SSD-94006708 RESPONSE TO SUBMISSIONS COVER LETTER
PROPERTY AT 15-21 Cottonwood Crescent

Re: 88 Waterloo Road, Macquarie Park NSW

Specifically, this letter provides an overview of the amendments made to Appendix N Landscape Design Report and Drawings in response to the DPHI request for additional information on 25th May 2026 and relevant agency comments.

Table 1 – Response to Agency Comments DPHI Key Issues

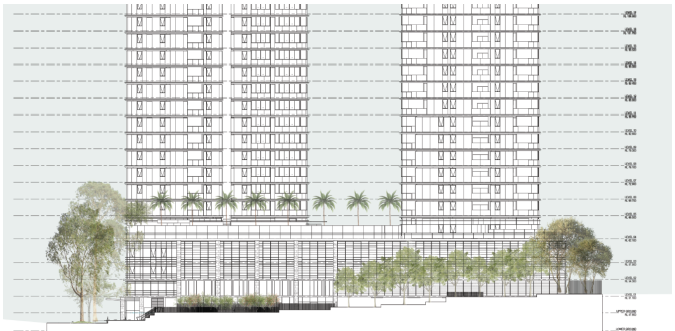
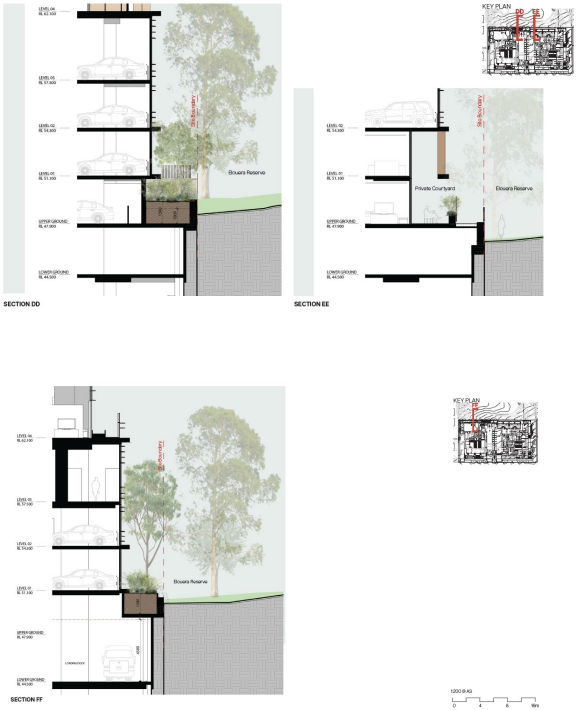
C	Design Quality: The proposal's podium interface with Elouera Reserve is suboptimal due to limited setbacks and four levels of car park screening across approximately half of the	The podium setback to Elouera Reserve has been increased in localised areas to retain tree T41 along the boundary. To offset the visual bulk of the podium,

frontage. While three trees are proposed along this boundary to offset the visual bulk of the podium, their establishment and growth would be constrained by the podium two storeys above and basement parking below. The podium setback to Elouera Reserve must be increased to facilitate tree retention, additional tree planting, improved building interface and reduce perceived bulk.

extend areas of planting suitable for tree planting with 1.5m soil depth have been increased and an additional 10 trees have been added along the Elouera Reserve interface to assist in screening the car parking.

Additional elevations have been provided from Elouera Reserve to demonstrate the increased landscape zones achieved.

Refer Planting Strategy – Page 45 of Design Report

Refer Elouera Reserve Elevation GG – Page 38 of Design Report

Refer Elourea Reserve Sections DD, EE, FF – Page 36 – 37 of Design Report

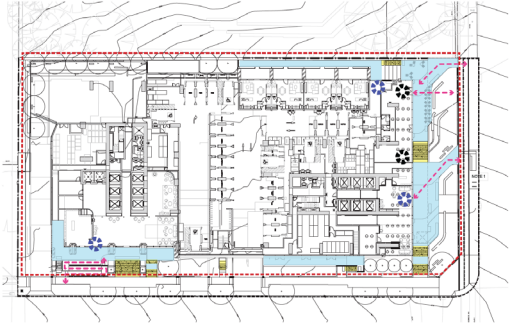
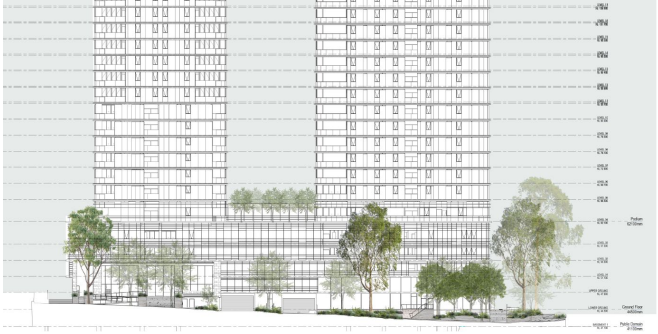
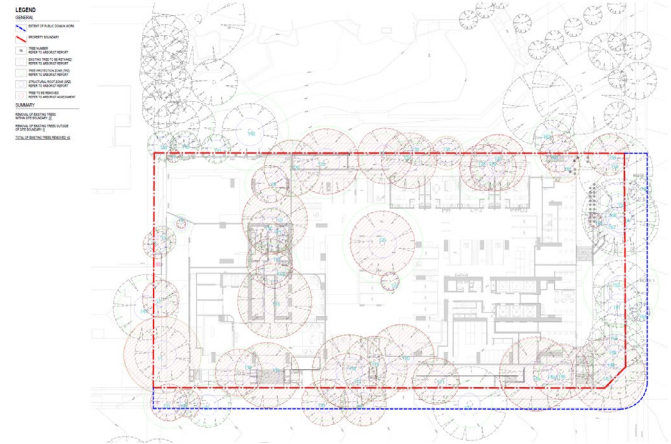
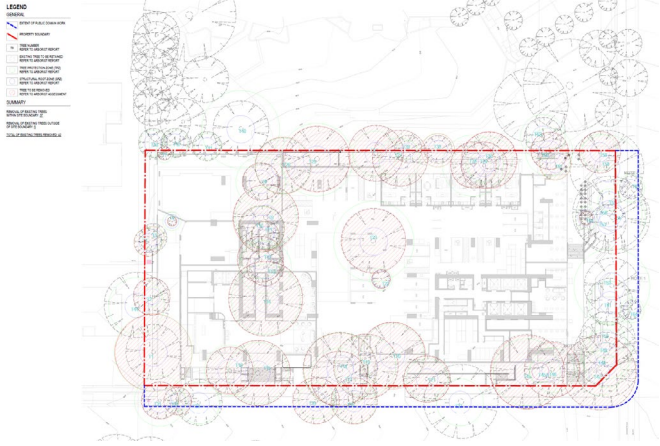
Design Quality:

The accessible entry to the Waterloo Tower lobby is through an informal decked seating area. This does not present as a clear and legible main building entry. The design and location of accessibility points to main residential lobbies must be prioritised to establish a clear and publicly accessible street interface.

The re-design of the Waterloo Road interface to accommodate the changes to the retail provide accessible entry points which present as a clear and legible main building entry connecting to the publicly accessible street interface.

This is achieved through simplified wide pathways following the direction of travel along paved footpaths, supported on root bridge systems for areas within the existing tree TPZ zones.

Refer Landscape Masterplan – Page 26 of Design Report

Refer Accessibility Plan – Page 44 of Design Report ● ACCESSIBILITY LANDSCAPE MASTERPLAN LEGEND - Site Boundary - Level Access - Stairs - Accessible Routes to Entrances - Residential Entrance - Detail Entrance 
E	Design Quality: The submitted elevation drawings do not sufficiently detail the proposal's design response to streetscape, context and public domain.	Please refer to landscape elevations for streetscape and public domain along Waterloo Road and Cottonwood Crescent frontage.	Refer Elevation CC – Waterloo Road – Page 32 of Design Report
